SECTION 00 91 15

ADDENDUM NUMBER 6

- 1.01 DATE: APRIL 6, 2021**
- 1.02 PROJECT: WELCOME CENTER**
- 1.03 PROJECT NUMBER: DCM NO. 2020604**
- 1.04 OWNER: ALABAMA A&M UNIVERSITY**
- 1.05 ARCHITECT: NOLA | VAN PEURSEM ARCHITECTS, PC**

EIFS - VERTICAL WALL & SUSPENDED SOFFIT
12\"/>

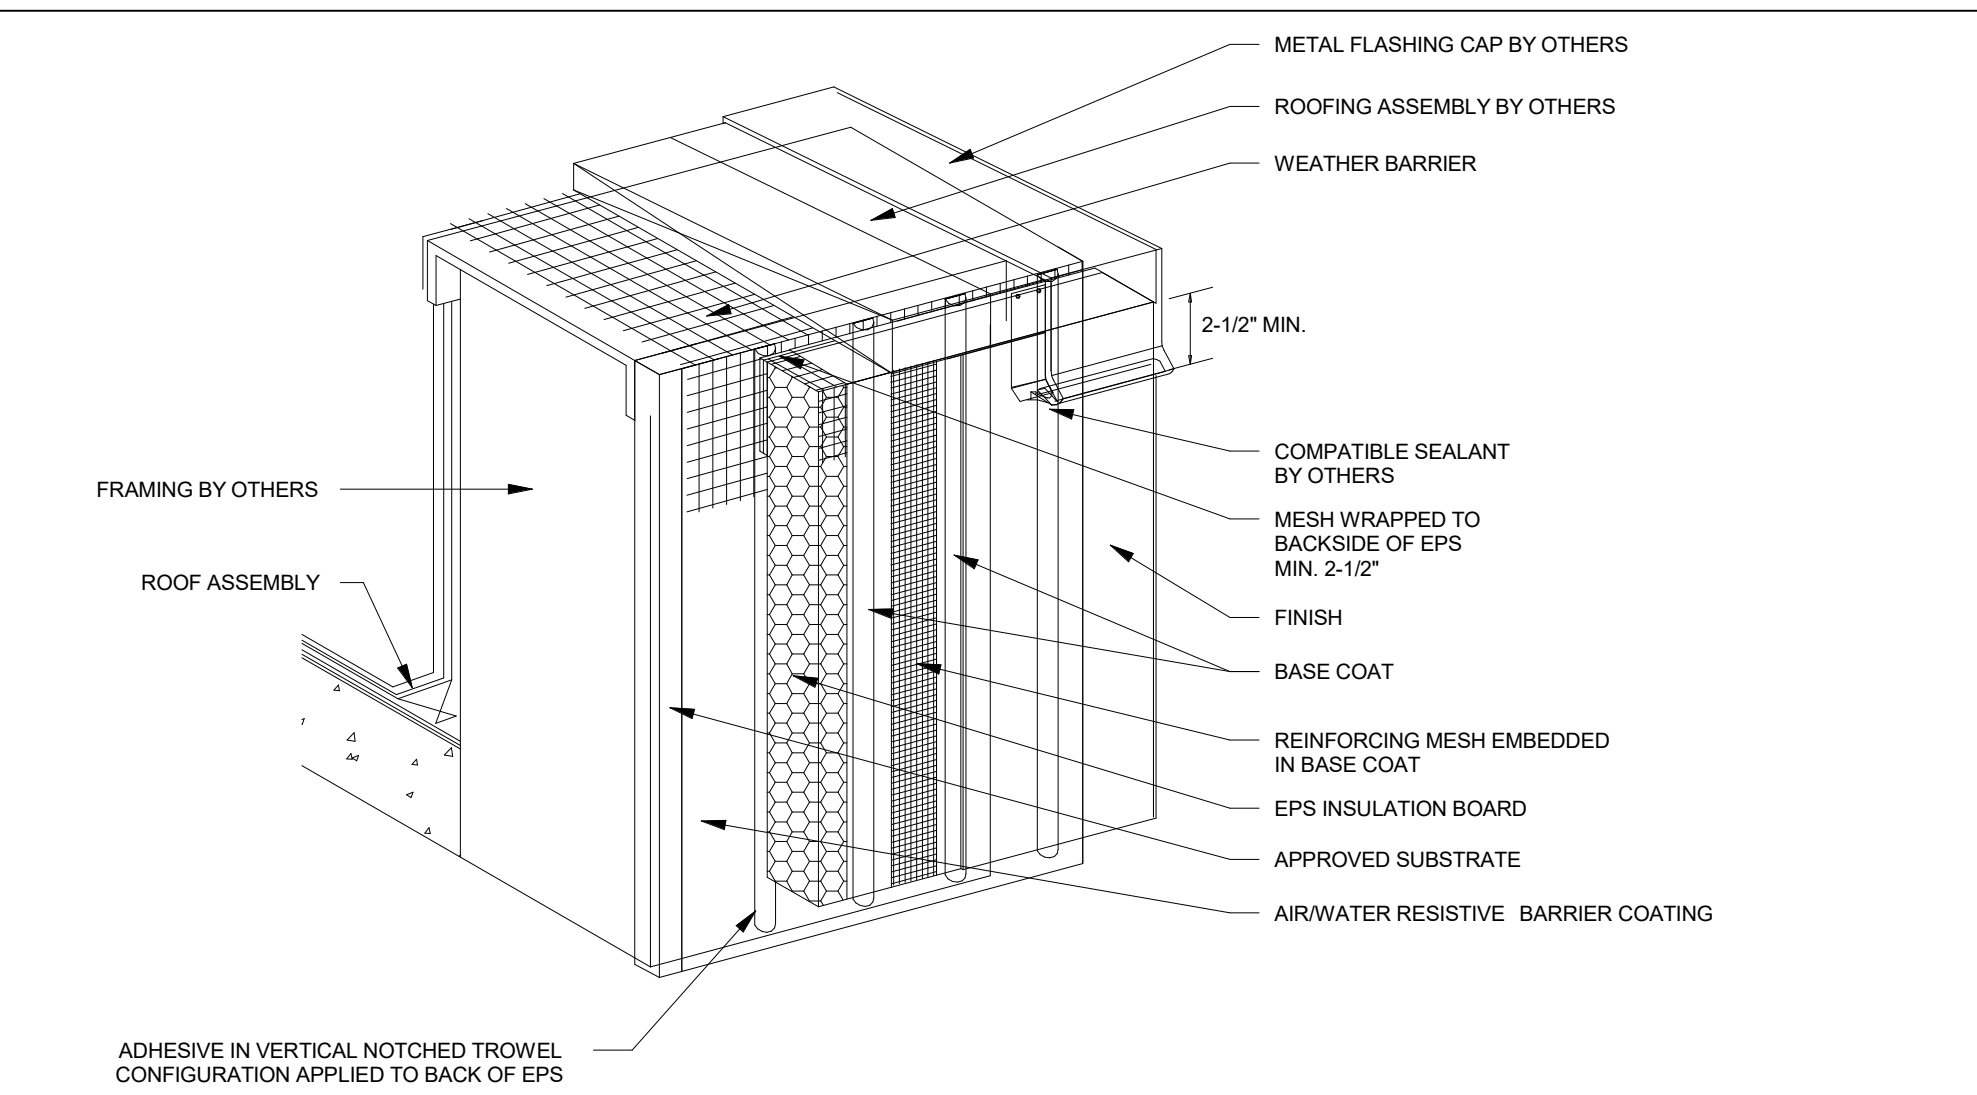
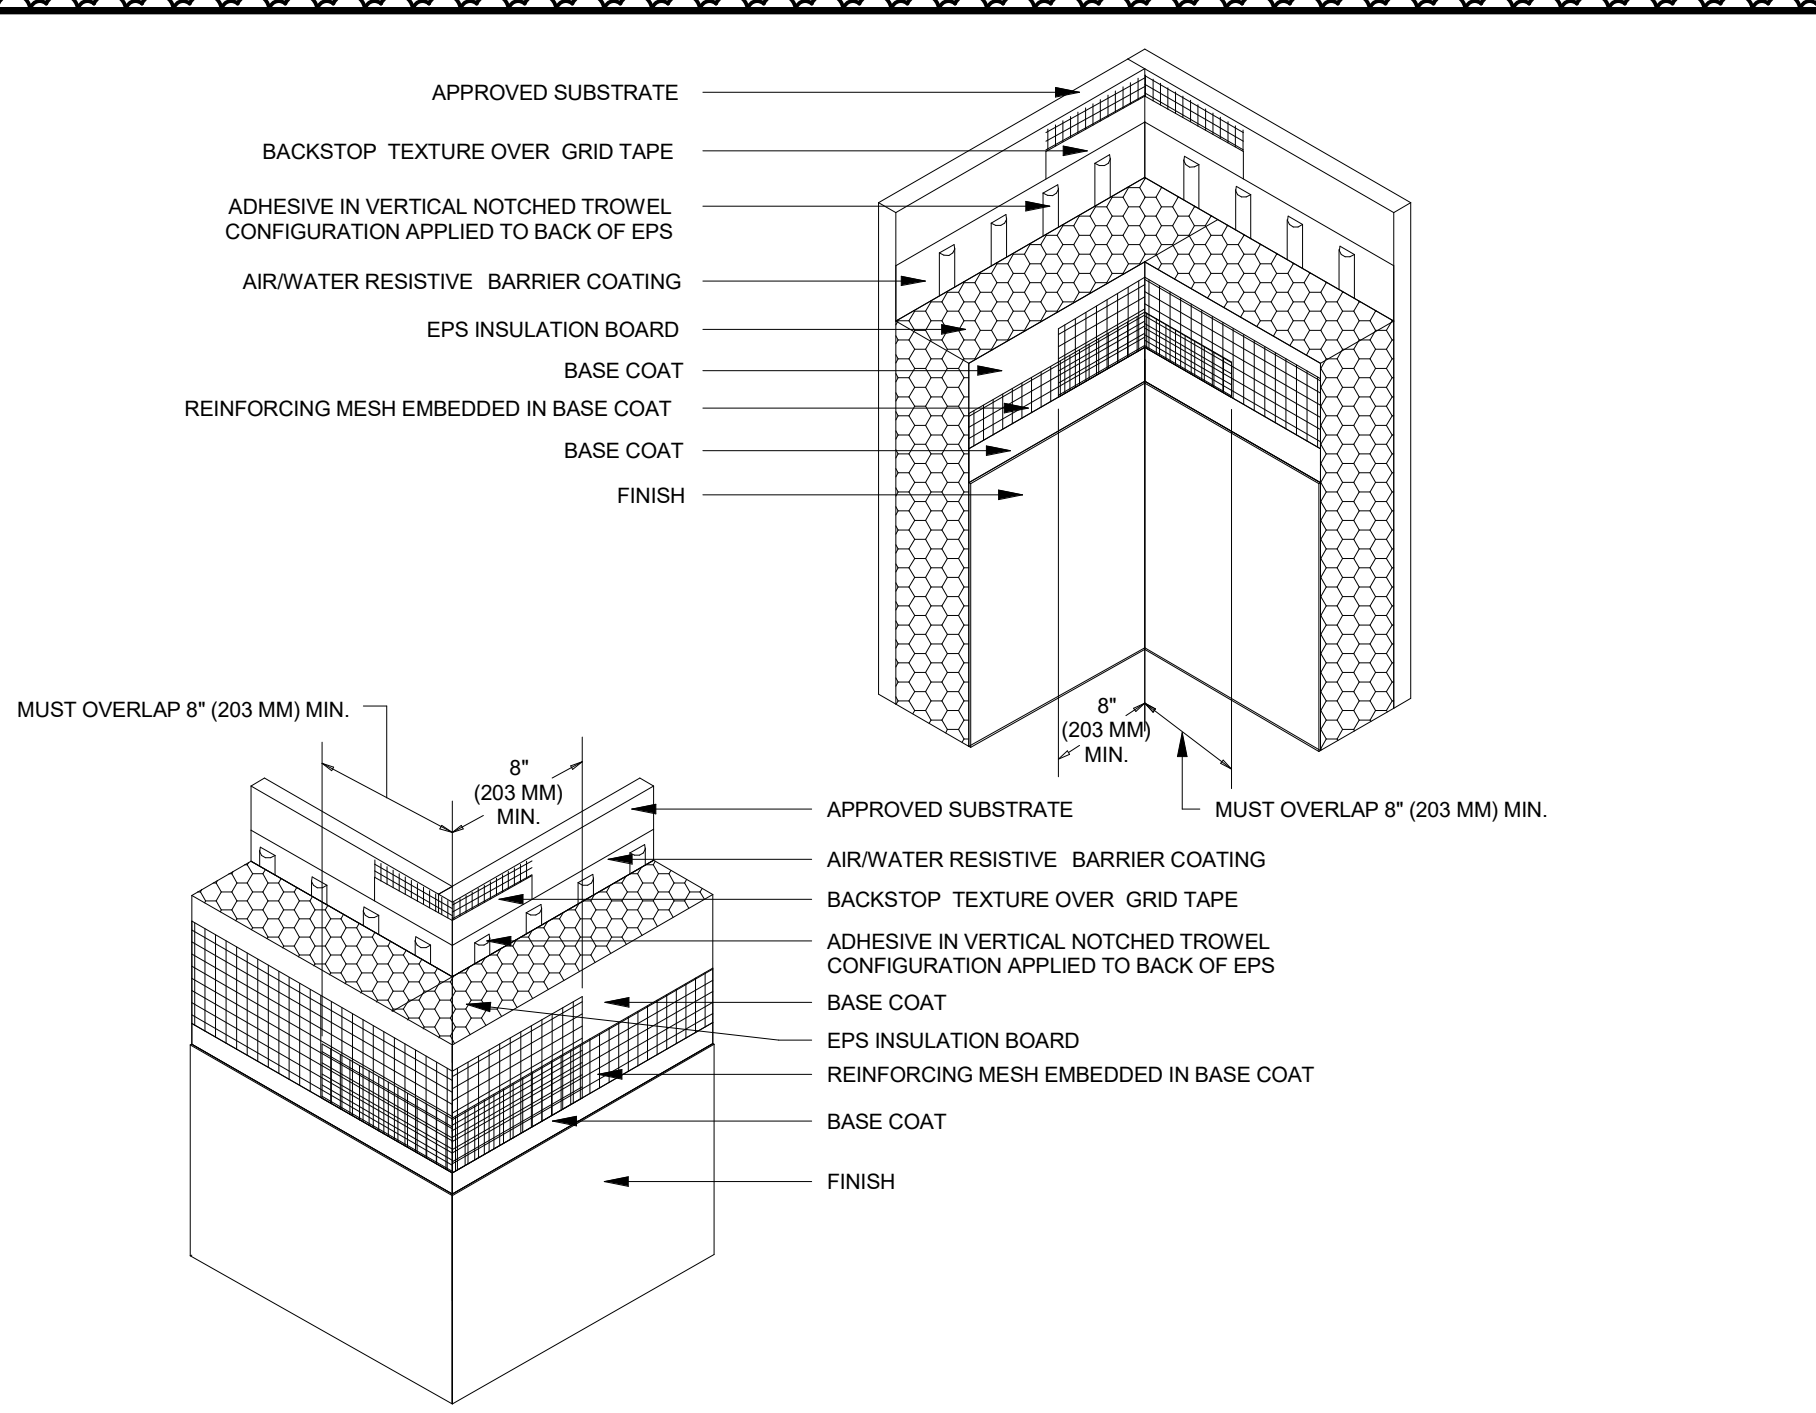
4.12 SHEET A-5.5 – CURTAINWALL DETAILS:

- A. Replace this sheet in its entirety. Revisions include the following:
1. Adjusted dimensions and notes on curtain wall details.
 2. Added EIFS details.
